Preserve Wild Santee

July 13, 2020

RE: Fanita Draft Revised EIR (DREIR)

9.2.3 Fire Behavior Modeling and Fuel Modification Zones

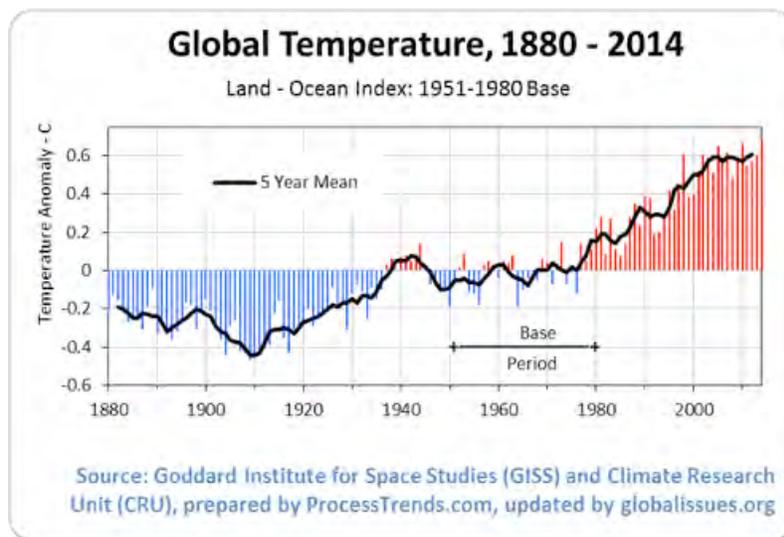
1. The 2007 FPP appropriately used FM4 for the chaparral in the northeast portion of the site and utilized other fuel models for other portions of Fanita. **The 95 foot flame length estimated is reasonable** and under estimates the intensity in more severe low humidity and high wind conditions. [AR 018490 “...flame length usually exceeding 100 feet.”]

2. The Cedar Fire does not represent the highest potential wind speeds. Higher wind speeds can and have been generated even if those wind speeds did not result in a major regional fire.

4. The FPP makes the false assumption that climatic conditions are constant. It ignores documented trends for greater extremes in weather and fire behavior.

9.2.4 Susceptible Project Design

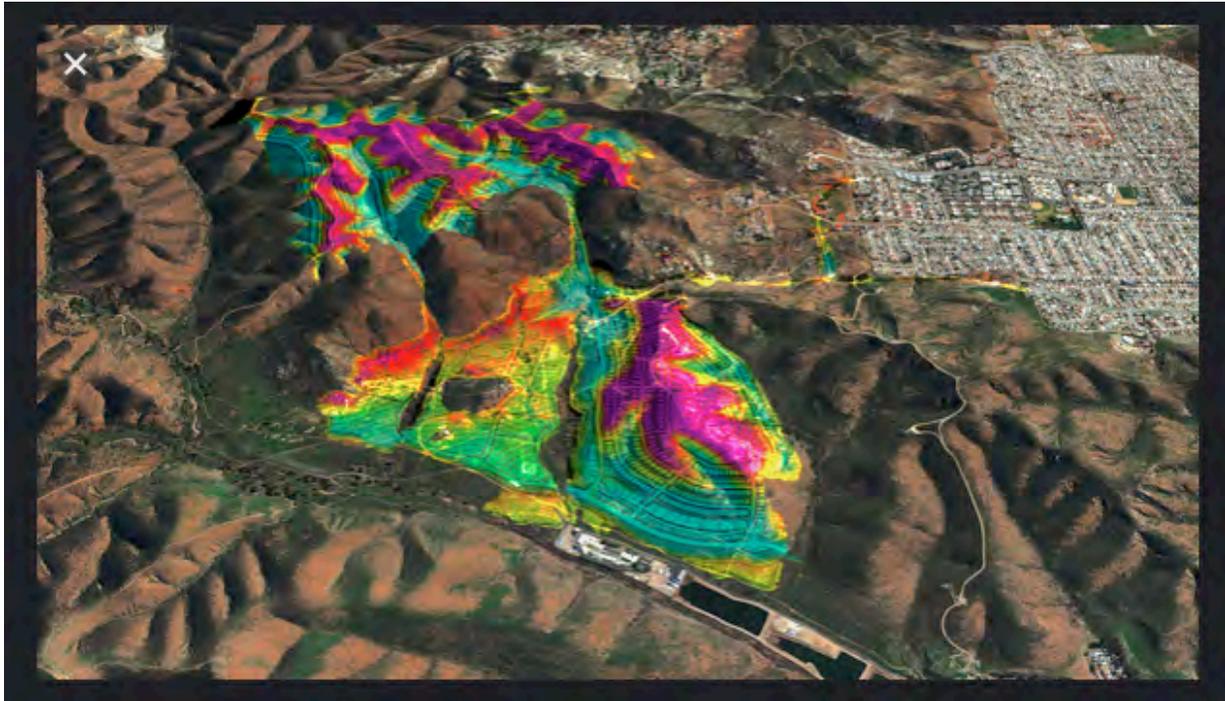
An aerial of the 2020 project design reveals structures located above numerous fire chimneys required to evacuate over roads subject to flame lengths exceeding 100 feet.

It is agreed that the 2007 land plan was a susceptible project design. However, the 2020 plan still places susceptible development above FM4 fire chimneys on the north and eastern exposed interfaces. This significant impact to public and firefighter safety should be avoided by removing the northeast island of development.

[B-7] Table 3 BehavePlus Fine Dead Fuel Moisture Calculation

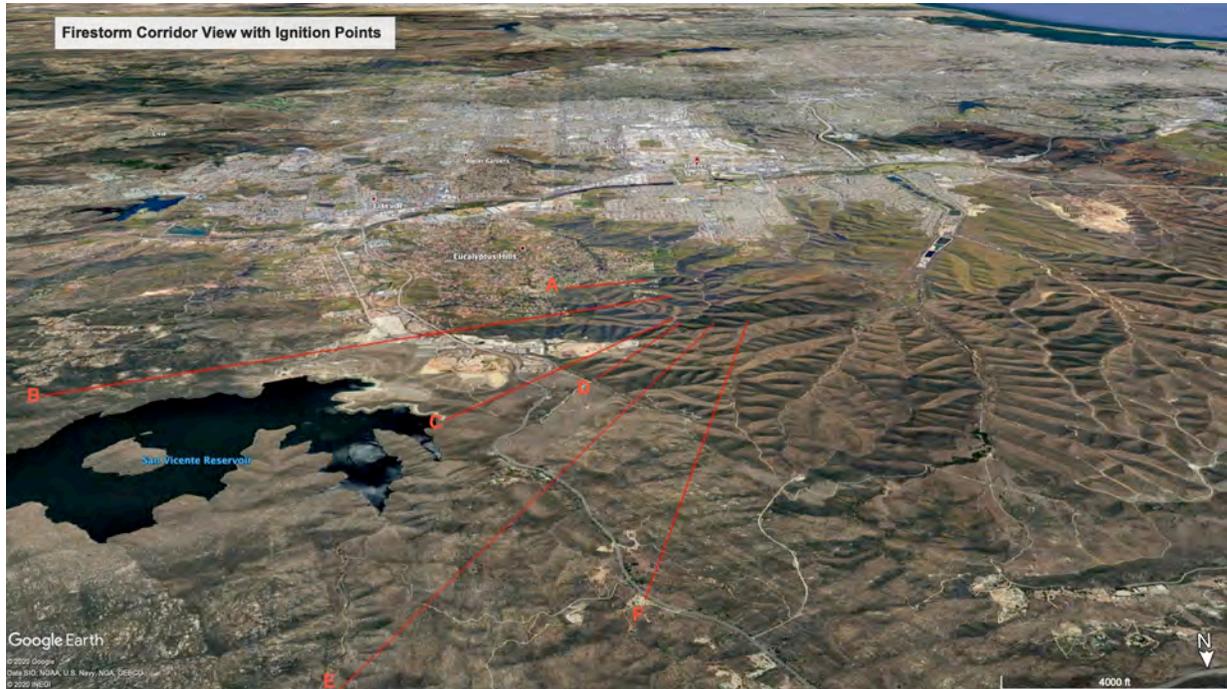
“Dry Bulb Temperatures 90-109 deg F” underestimate peak temperatures for the site that approach 120°F.
